Access Compliance Report

Public Rights-of-Way

(Curb Ramps)

Intersection ID: 10039822	Main Street: TOM_SHORT_RD	Cross Street: N/A	Location: NW
ADA ID: AE816105E2DB	Ramp Type: PerpDiag	Initial Pass/Fail: Fail	Overall Compliance: No
		Severity Score: 12.5

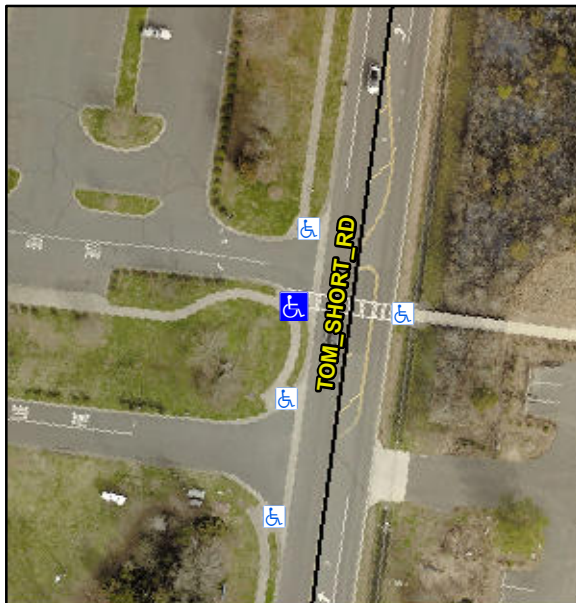
Not Found, R304.2.2

Compliance	Description	Data	Compliance	Description	Data
N/A	Ramp Length (in)	47.0	No	Ramp Slope (%)	8.6
Yes	Ramp Width (in)	58.0	Yes	Ramp XSlope (%)	0.7
N/A	Flare Type LT	N/A	N/A	Flare Type RT	N/A
N/A	Flare Slope LT (%)	N/A	N/A	Flare Slope RT (%)	N/A
N/A	Flare Traversable LT?	N/A	N/A	Flare Traversable RT?	N/A
N/A	Landing Length (in)	N/A	N/A	DWS Provided?	N/A
N/A	Landing Width (in)	N/A	N/A	DWS Contrast?	N/A
N/A	Landing Slope (%)	N/A	N/A	DWS Length (in)	N/A
N/A	Landing X Slope (%)	N/A	N/A	DWS Full Width?	N/A
N/A	Landing Curb? (Y/N)	N/A	N/A	DWS Offset (in)	N/A
N/A	Shared Landing?	N/A			
N/A	Gutter Ponding?	N/A	N/A	Gutter Slope (%)	N/A
N/A	Gutter Lip Ht (in)	N/A	N/A	Gutter X Slope (%)	N/A
N/A	Painted X Walk1?	Yes	N/A	Painted X Walk2?	No
	X Walk 1 Direction	To SE		X Walk 2 Direction	To NE
N/A	X Walk 1 Width (in)	87.0	N/A	X Walk 2 Width (in)	N/A
	X Walk 1 Slope (%)	1.0		X Walk 2 Slope (%)	0.2
	X Walk 1 X Slope (%)	1.1		X Walk 2 X Slope (%)	1.0

Remove & Replace Curb Ramp With Two New Directional Ramps or Equivalent.
